UNITED STATES PATENT AND TRADEMARK OFFICE

10/597,913

Office Action Summary	Application No.		Applicant(s)	
	10/597,913		UHL, GUNTER	
	Examiner		Art Unit	
	SAMUEL BERHANU		2858

DETAILED ACTION

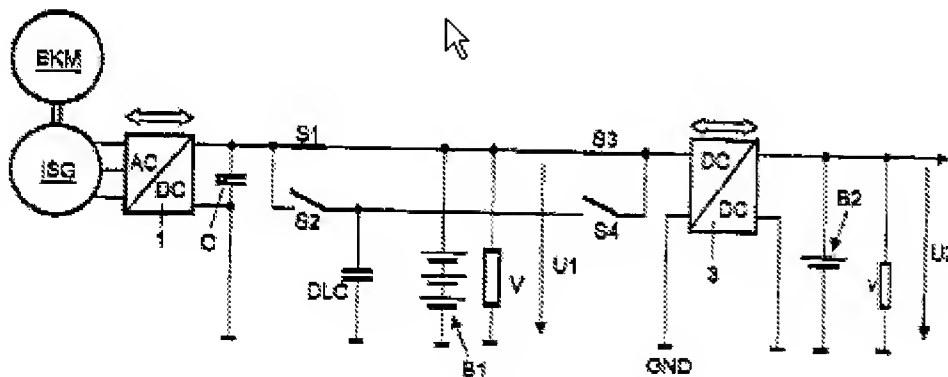
As to claims 20 and 31, Bolz discloses in figures 1-5 (see figure above), a motor vehicle electrical system, comprising:

a generator [ISG], a battery [B1], a starter and a high-capacity capacitor [DLC] for storing electric energy for the starting process of a motor vehicle engine [figure2],

a voltage transformer [DC/DC] and an interrupter [S1, S2] which are connected in parallel between the capacitor and the battery [see figure above] and which are

controlled for preparing a starting process of the motor vehicle engine in such a way that the voltage transformer transforms the voltage (UBatt) of the battery into a larger voltage [column 3, lines 58-61] and the interrupter interrupts the electrical connection between the battery and the capacity [column 8, lines 11-15].

As to claim 22, Bolz discloses in figure above, a control unit for activating the voltage transformer and for opening the interrupter [column 8, lines 11-15].

As to Claim 23, Bolz discloses in figure above, wherein the control unit effects an activation of the voltage transformer and an opening of the interrupter for a short time prior to the start of the starting process of the motor vehicle engine for charging the capacitor [Column 10, lines 5-19].

As to claim 26, Bolz discloses in figure above, wherein the control unit activates the voltage transformer and opens the interrupter in dependence on the detection of the position of the ignition key [column 10, lines 5-19].

As to claim 37, Bolz discloses in figure above, wherein the battery is electrically connected to the generator as soon as the motor vehicle engine runs by itself [column 8, lines 11-15].
